Fire Safety Assessment of Ausgrid Advice on Option 4

**2-10 Anderson Street, 47-55 Bunnerong Road,
Kingsford, NSW 2032**

Reference ► F3709 FSA Rev 01

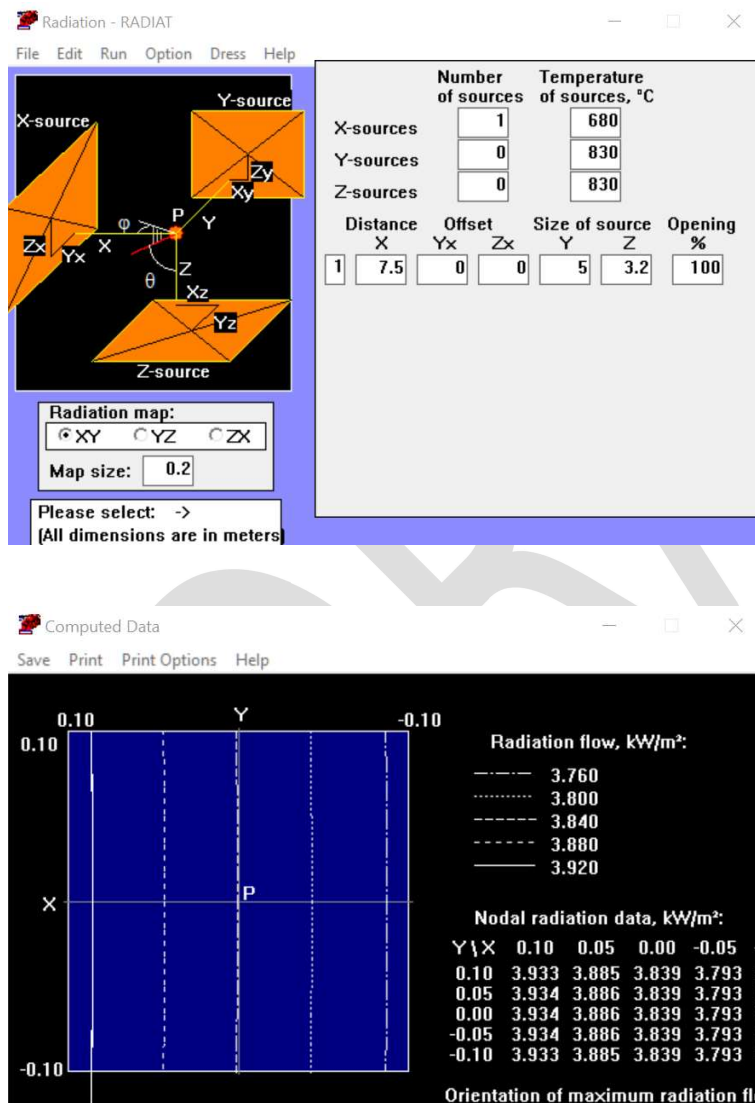
It is noted that the set backs provided to AED Fire by the department show set backs of 7.1m and 7.5m. It is uncertain how these relate to the actual transformer bays. It is also reasonable to assume that the Ausgrid set back includes the structure bounding the transformer bay.

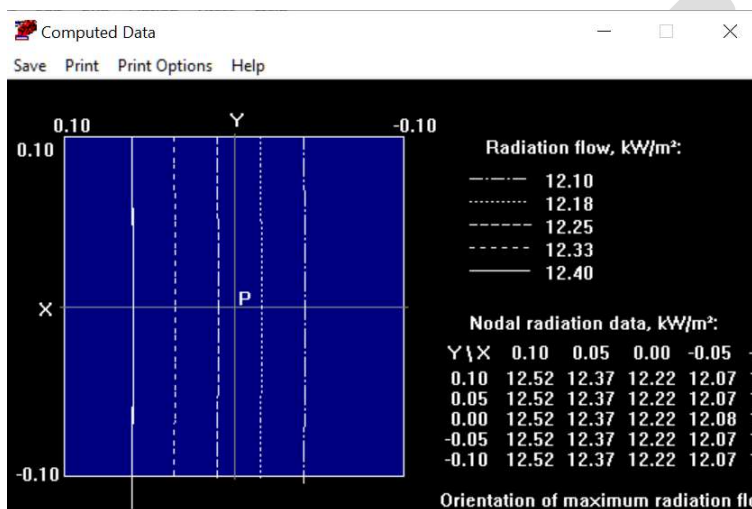
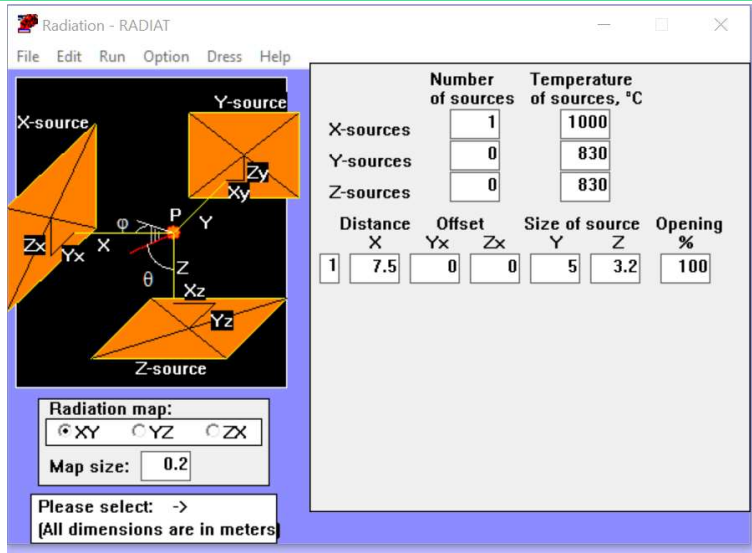
Assuming a wall 8.8m high and a plume 12m high, the boundary and hence the building is exposed to 3.2m high flame front 5m wide.

If the flame temperature is 680°C¹, the following calculation suggest that the radiant heat flux on the boundary is in the order of 3.8kW/m².

As a check calculation, a conservative assessment based on a flame temperature of 1000°C gives a heat flux of 12.22kW/m².

The calculation shows that the radiant heat flux incident on the boundary to be no greater than 12.22kW/m² and most likely to be 3.8kW/m². As C1V1 requires that a building not radiate a heat flux that results in 80kW/m² at the boundary the calculations show that the location of the substation in relation to the proposed Option 4 building meets and complies with the NCC as assessed under verification method C1V1.
